GENERAL APPLICATION

SUBJECT: Preliminary Site Plan review for a 15-unit residential development (Mayo Apartments).

PROPOSED 15-UNIT MULTI FAMILY
DEVELOPMENT FOR:
XLT INVESTMENT CORP.
1700 MAYO STREET
HOLLYWOOD, FLORIDA 33020

DRAWN	CC.
CHECKED	LLR
DATE	05/30/18
SCALE	AS NOTED
JOB. NO.	018-018
SHEET	C-1.1
OF	SHEETS

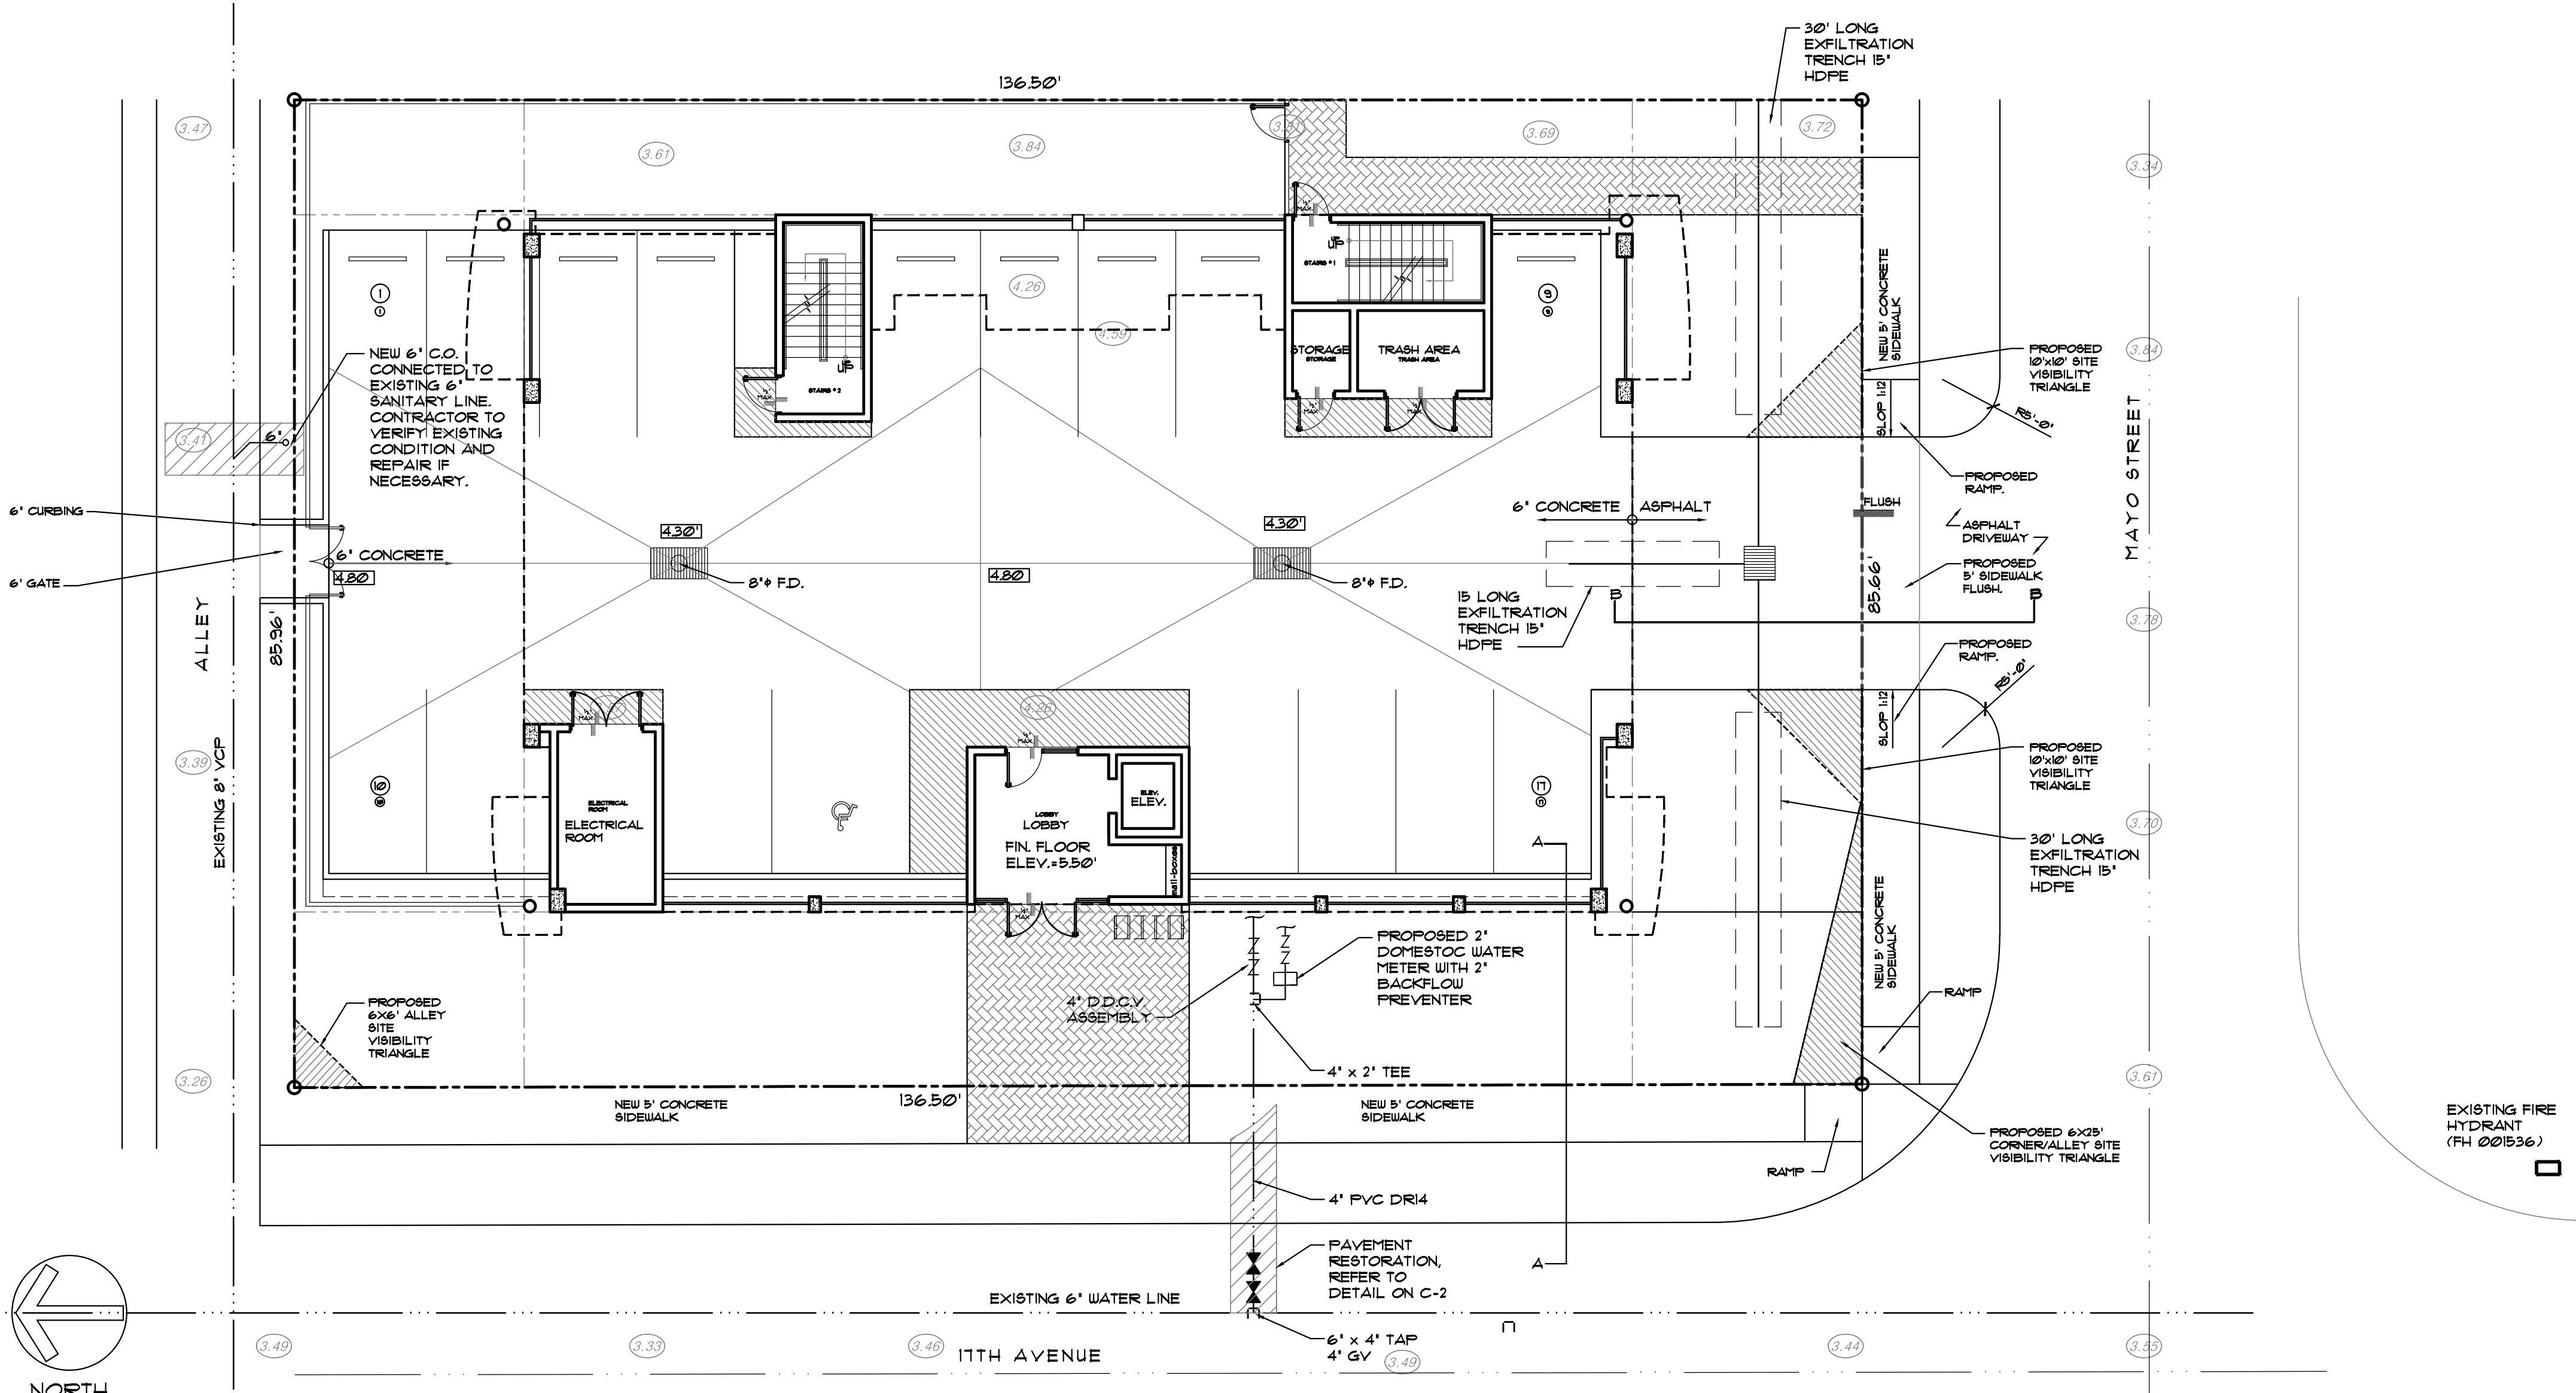
Response: Provided
3. Revise the Panel No. to 12011C0732 in Note #6.
Response: revised
4. Show existing 2-inch water main within alley and corresponding water meter on Sheet C-1.1.

Response: Provided
5. Provide additional cross sections on west side and south side indicating swales.
Response: provided
6. Indicate how roof drainage will be collected and retained.

Response: OK
9. Provide proposed catch basin elevations.
Response: Provided
10. The transverse trench section shows the proposed grade elevation at 8.00' NAVD. That does not match

2. Show the closest fire hydrant on the plan and distance from the building.

3. Show the proposed fire department connection on the plan.

Response: Refer to C-1.1
7. Provide drainage calculations.
Response: OK
8. May need to show additional standard details such as for water and sewer notes (W-01, W-02), cleanout (S-12), tapping and water service from meter (W-10), etc.

Response: revised

Response: Refer to C-1.1

Response: Refer to C-1.1

7 PROPOSED SITE PLAN

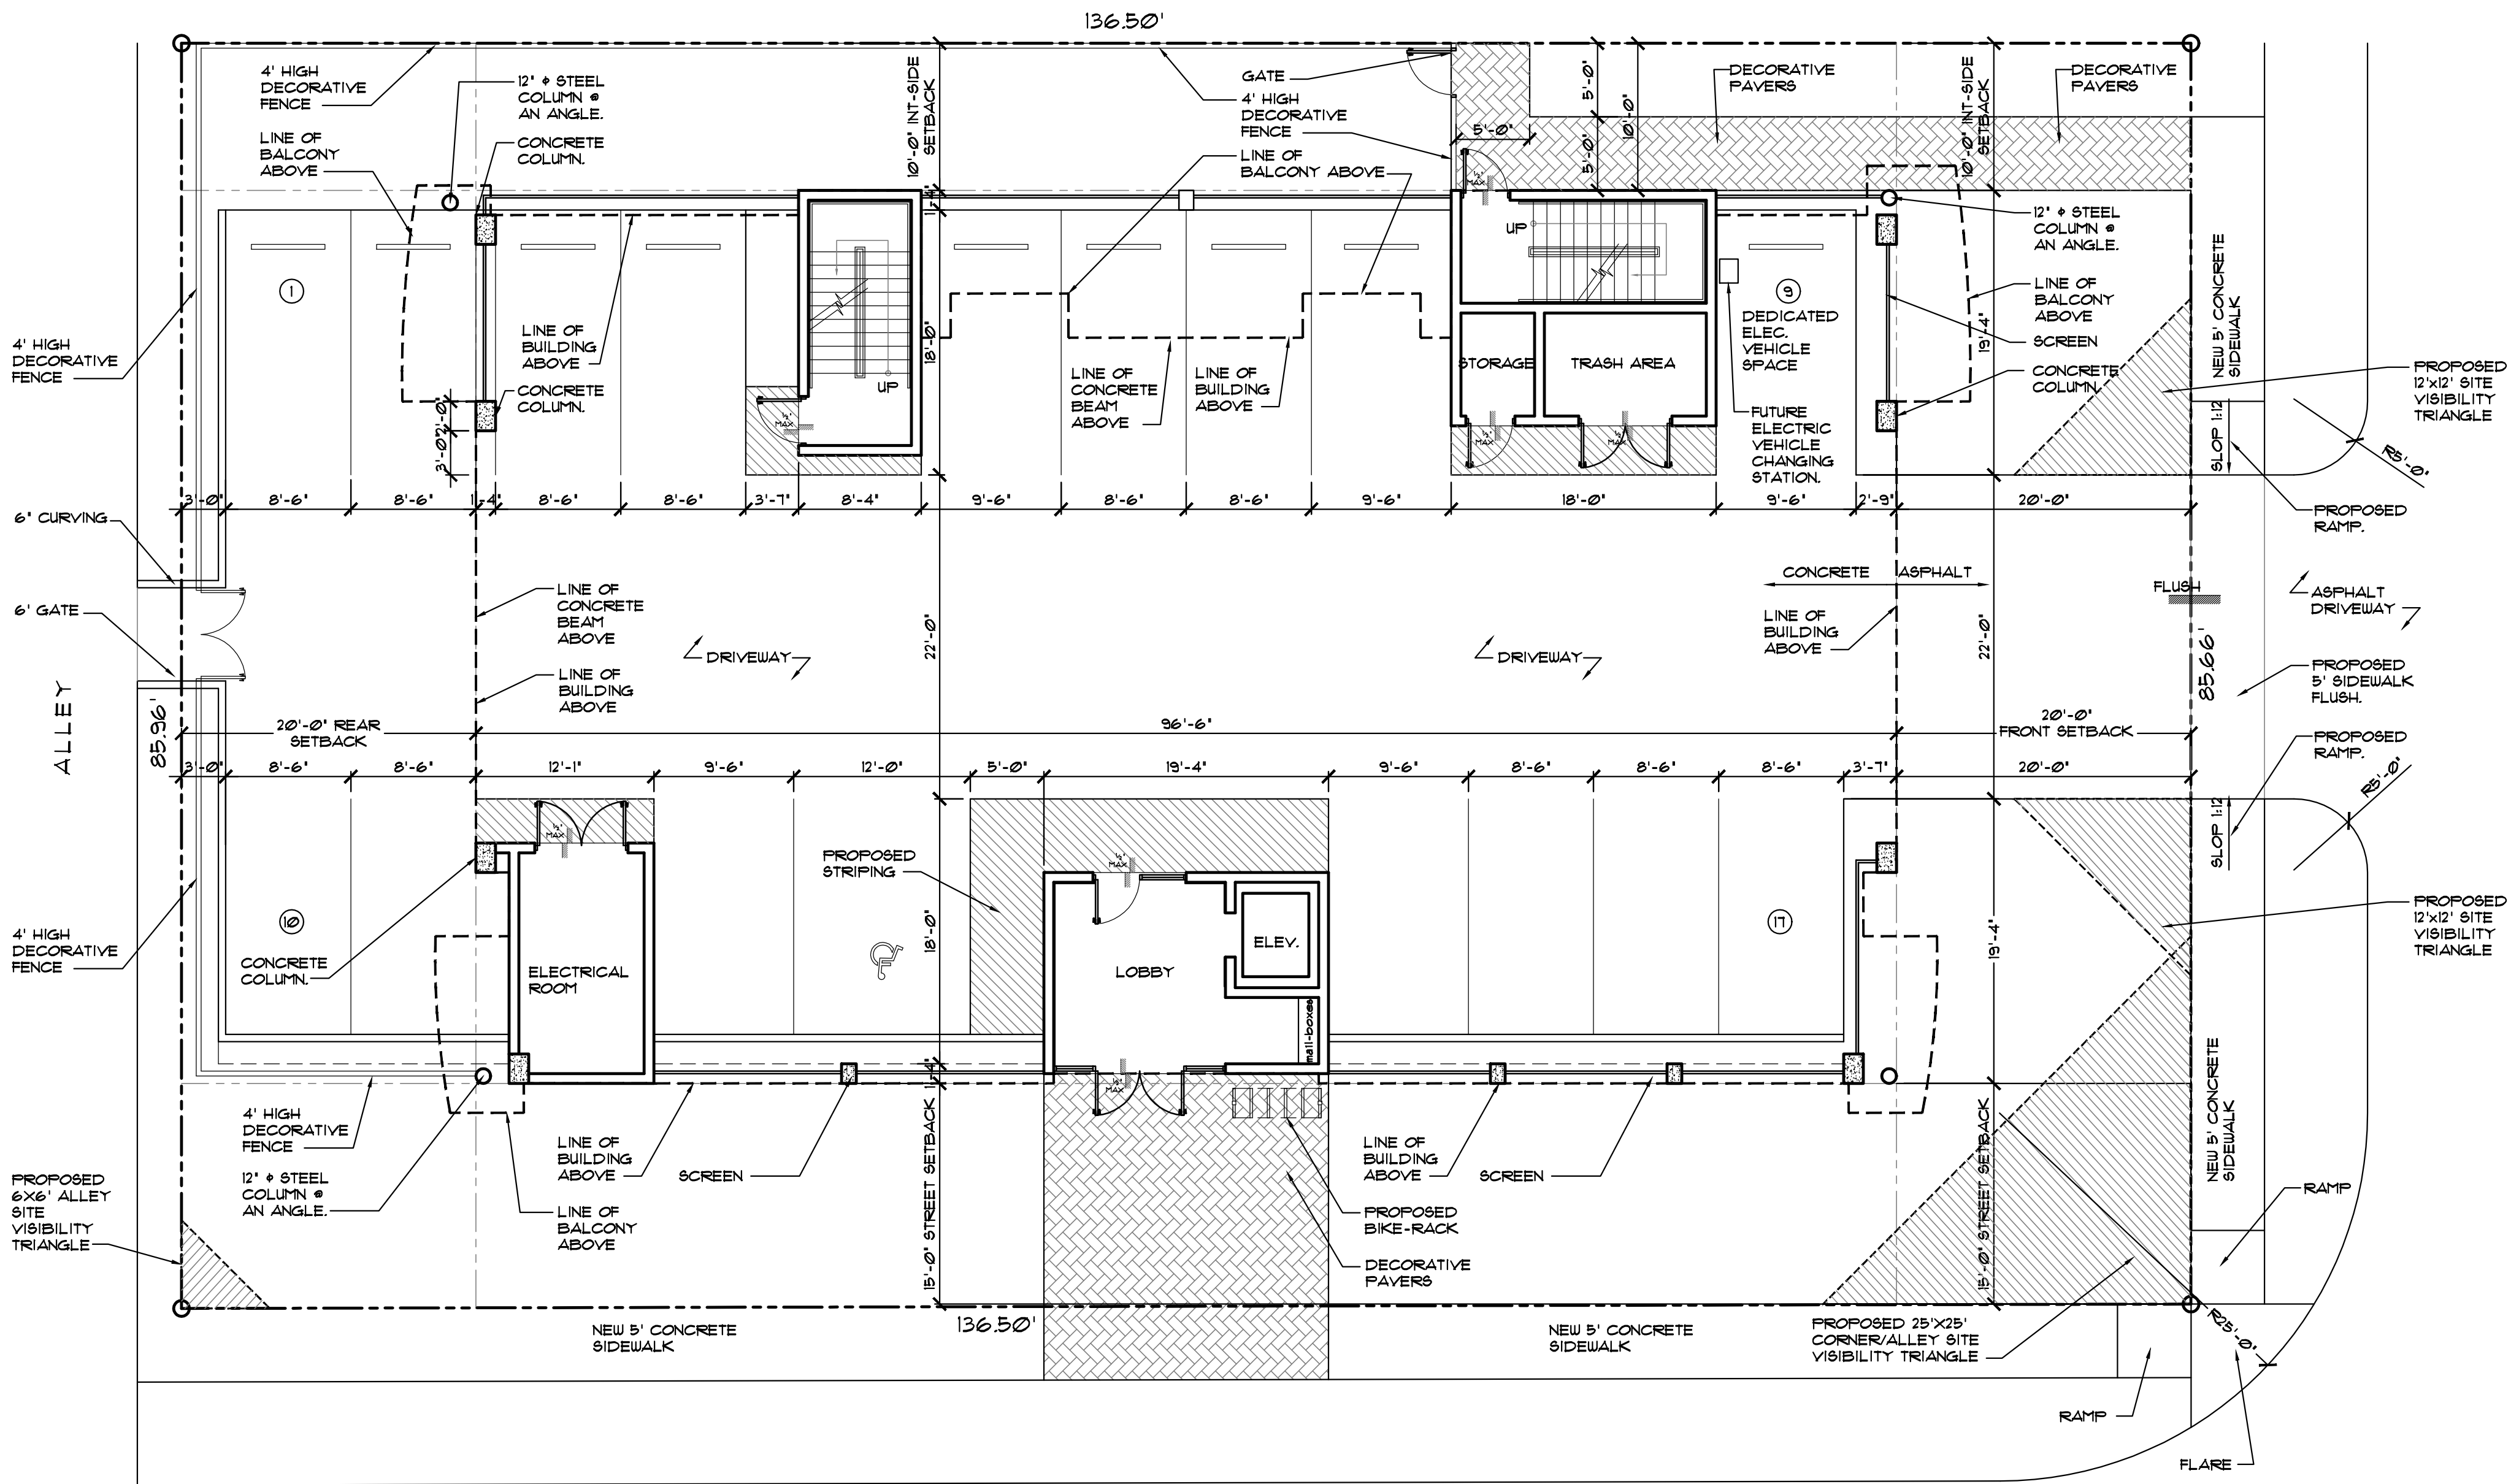
2. Provide detail of the proposed decorative fencing.

1. Indicate location of mail boxes/services on plan.

5. Parking Stall 9 is adjacent to the stairwell and minimum width is 9.5'. Please provide.

6. Parking Stall 10 is adjacent to an obstruction and minimum width is 9.5'. Please provide.

7. Indicate column distance from the entrance of Parking Stall 10, minimum distance is 3'.
Response: Refer to SP-1.1
8. Revise Sheet C-1.1 to reference the correct page for civil details.
Response: OK
9. With the level of construction activities for the proposed development, full road width pavement resurfacing abutting to the site (Mayo Street, South 17 Avenue and the alley) will be necessary, please indicate on civil plans.
Response: Note provided on C-1.1
10. Park impact fees will be required prior to issuance of Building Permit.
Response: OK
11. All outside agency permits must be obtained prior to issuance of City building permit.
Response: OK
12. More comments may follow upon review of the requested information.
Response: OK

Response: Provided on Sp-1.1

Response: Refer to SP-1.1-provided in Lobby Area

Response: Refer to SP-1.1

Response: Refer to SP-1.1
